United States Department of the Interior

NATIONAL PARK SERVICE
Water Resources Division
1201 Oak Ridge Drive, Suite 250
Fort Collins, CO 80525

Subject: Technical Assistance Request Report to Jewel Cave National Monument
Site Visit - May 16, 2012

Figure 1. Conceptual geologic cross-section in the vicinity of the Jewel Cave elevator shaft.

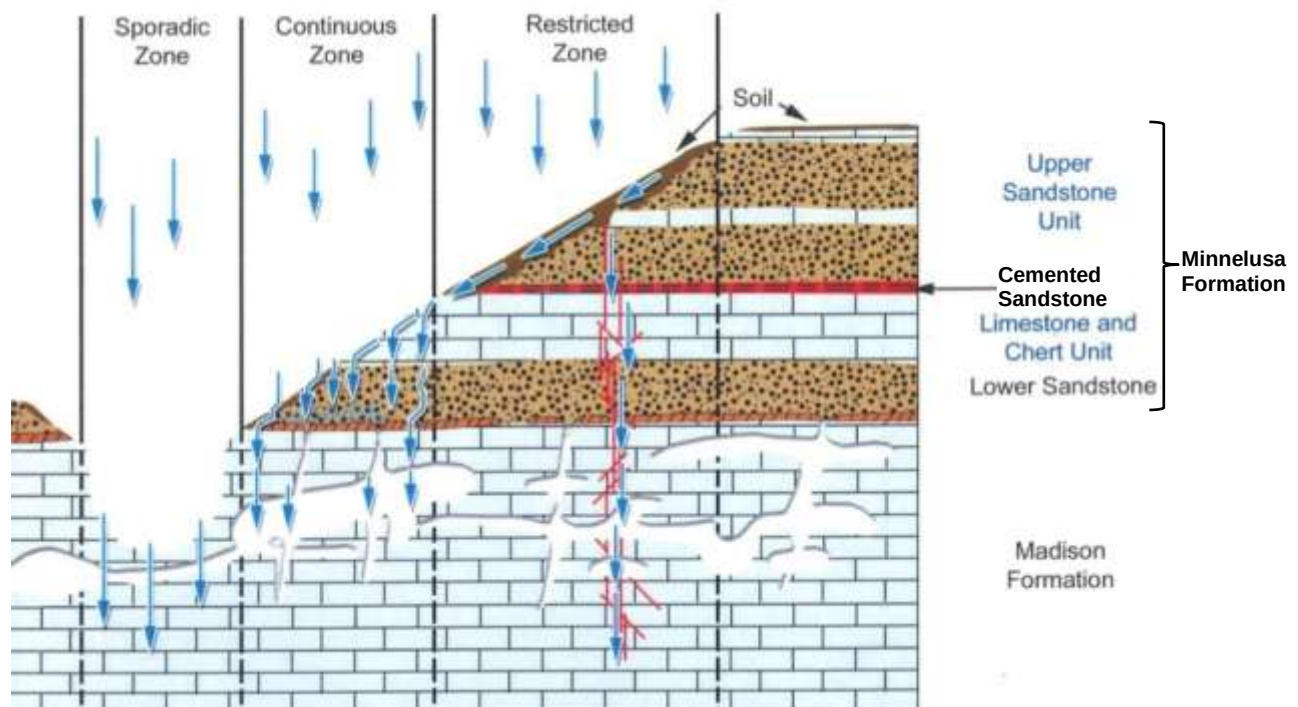
Hydrogeology – Figure 1 shows a conceptual geologic cross-section in the vicinity of the elevator shaft. The elevator can be thought of as occurring in the general location to the right of the center, and shown by the blue arrows indicating downward percolation of water and the red lines indicating fractures in the bedrock. We don't know that the bedrock in the vicinity of the elevator is fractured, but the figure provides an otherwise reasonable depiction of the geology.

Water infiltrating into the ground in the vicinity of the elevator will percolate downward until it reaches the impermeable layer (the cemented sandstone shown as a thin red layer on the cross-section). Water will then flow laterally until it finds an opening where it can percolate down through the cemented sandstone. That might be the elevator shaft, or it could be naturally occurring fractures in the bedrock. However, it is generally thought that the cemented sandstone provides an effective impermeable barrier to downward percolation because the cave is generally dry below wherever the cemented sandstone is present above.

Figure 3. Schematic cross-section of the elevator doorway at the cave lobby.
Blue arrows indicate pathways for water seeping into the doorway openings.

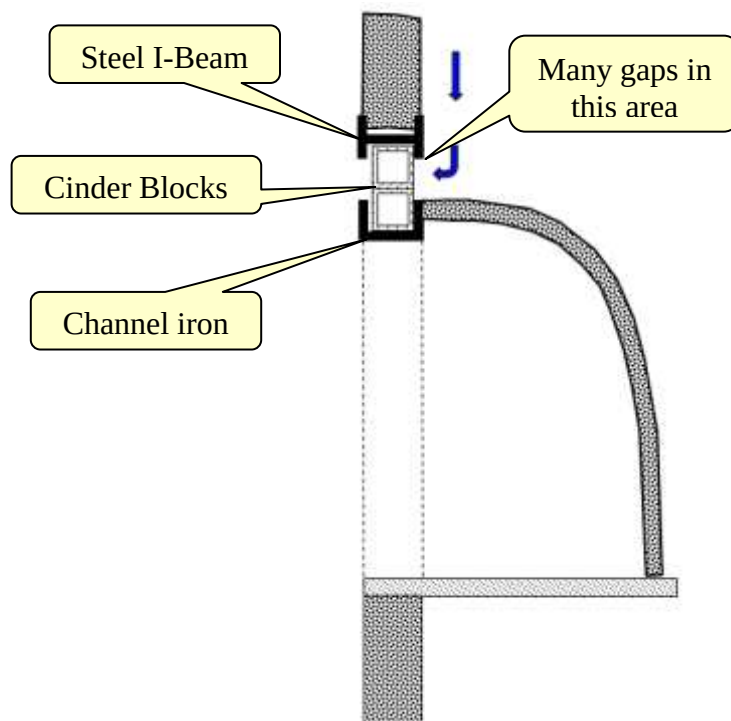
Headers above the elevator doorways at the cave levels are another area where water seeps in from behind the concrete walls. Figure 3 shows a schematic cross-section of a typical construction of the elevator doorway opening at the cave lobby. A steel I-beam is laid on its side as a header. Under the I-beam is a course or two of concrete blocks and then a piece of channel iron to frame the opening. There are a lot of gaps between steel, concrete, and bedrock in this area. Water seeps and drips into the elevator doorway, wreaking havoc with the steel components of the door and frame and eventually finding its way into the electrical components. The openings could be filled with some type of waterproof, expanding foam or epoxy materials. An example is found at this website <http://www.epoxy.com/420.htm>. Other materials are undoubtedly available and further research should be conducted to select an appropriate product. A series of weepholes should be drilled above and alongside the doorways to drain the water that will build up after sealing the openings at the top of the doorways. Otherwise the water will eventually develop enough hydrostatic pressure to leak in around the new seal. Water from the weepholes should be drained to the gutters and downspouts via flexible tubing, as with the other weepholes throughout the shaft.

2. Seal the openings at the headers above the elevator doorways at the cave lobby entrances. This will require some type of waterproof, expanding foam or epoxy. Drill a series of weepholes above and alongside the doors to drain water and reduce the hydrostatic pressure at the newly sealed areas above the doorways.
